Justification for Class III Permit Modification April 2001 SWMU 151 Operable Unit 1295 Building 9940 Septic System

Justification for Class III Permit Modification

SWMU 151

Building 9940 Septic System

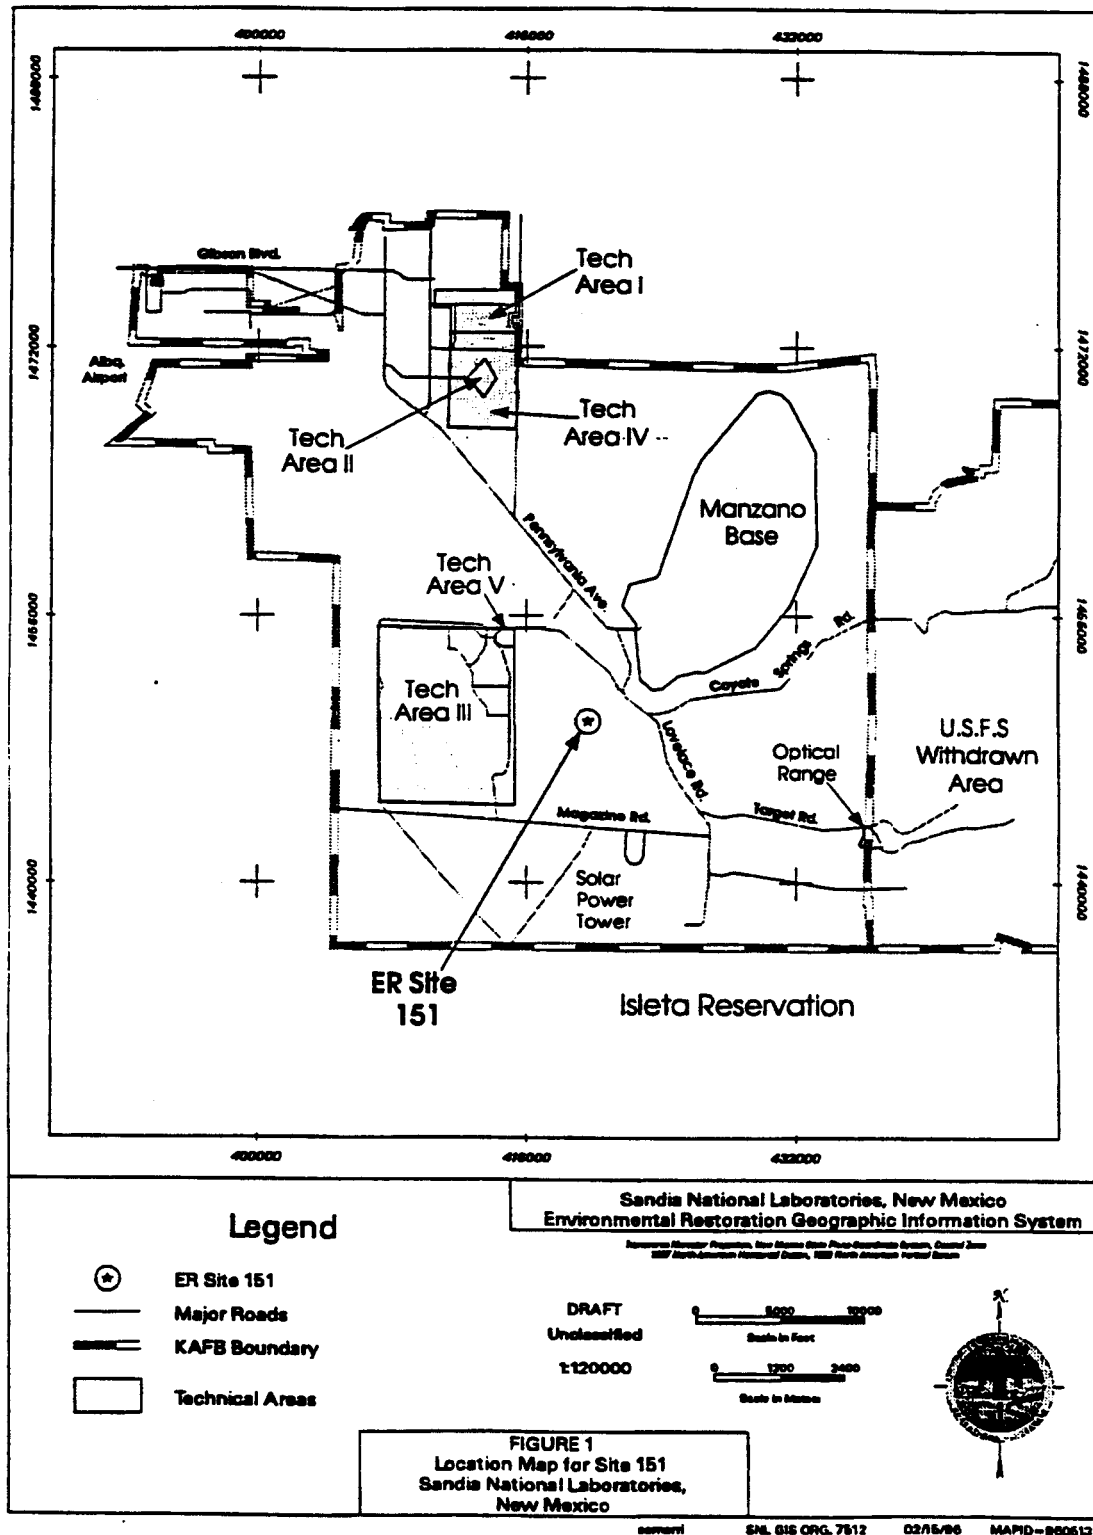
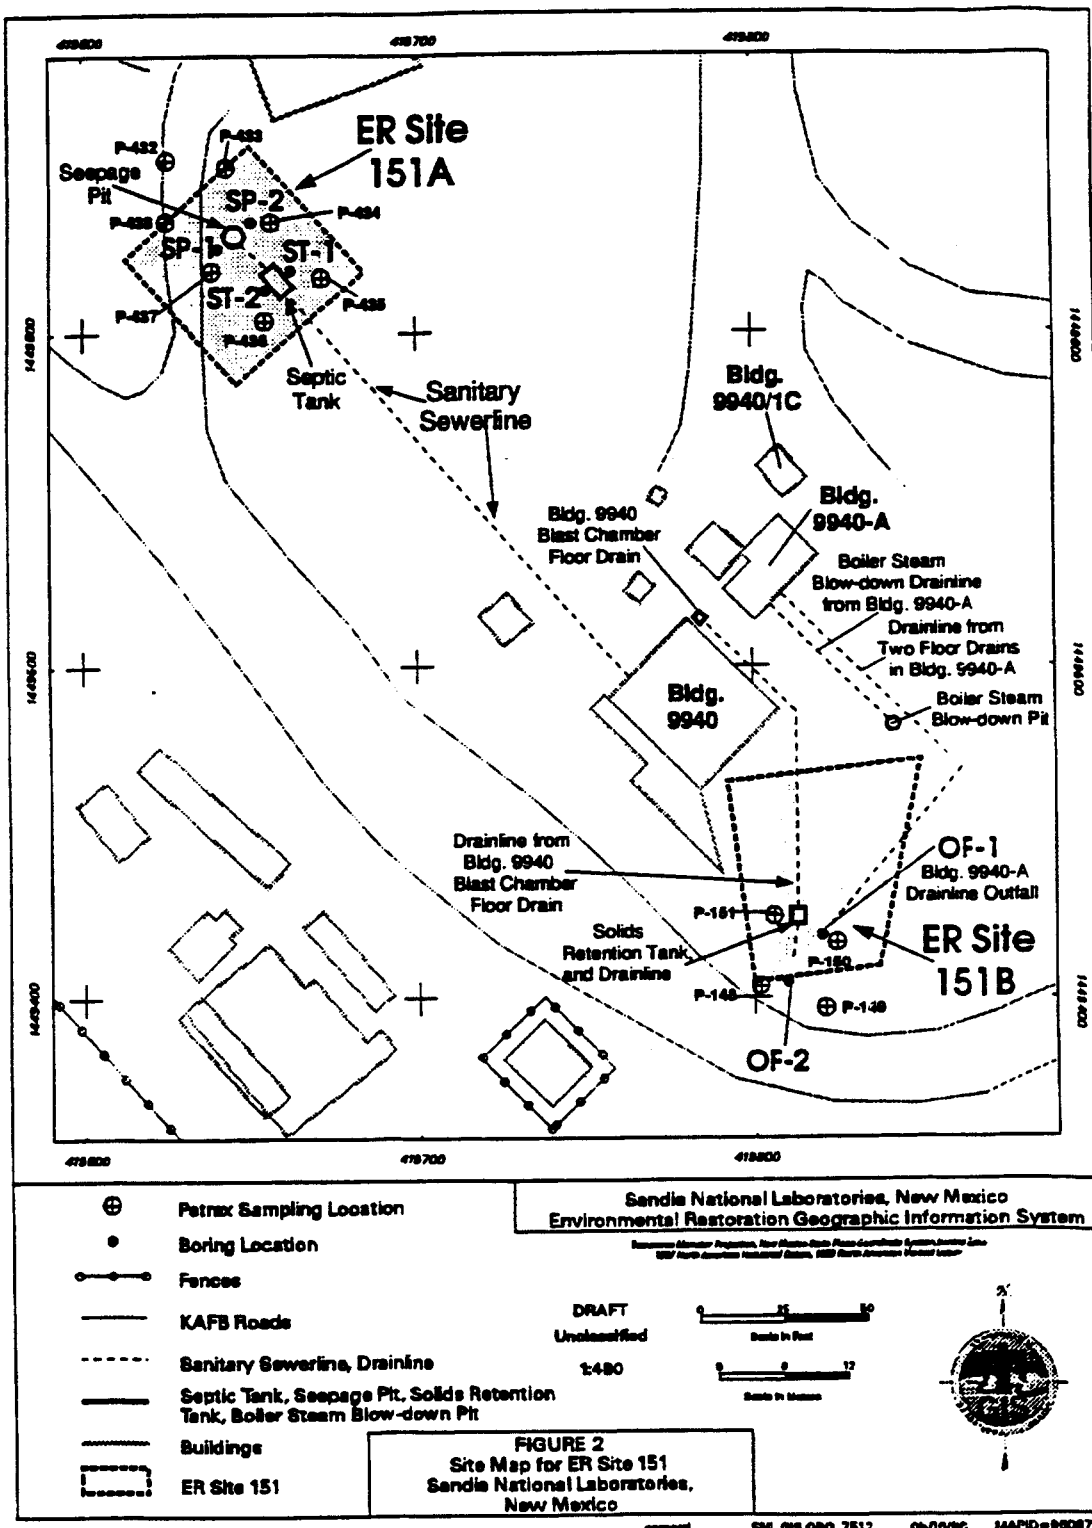
42. Figures 1-1 and 1-2 - see General Comment 1.

Response: See response to General Comment 1.
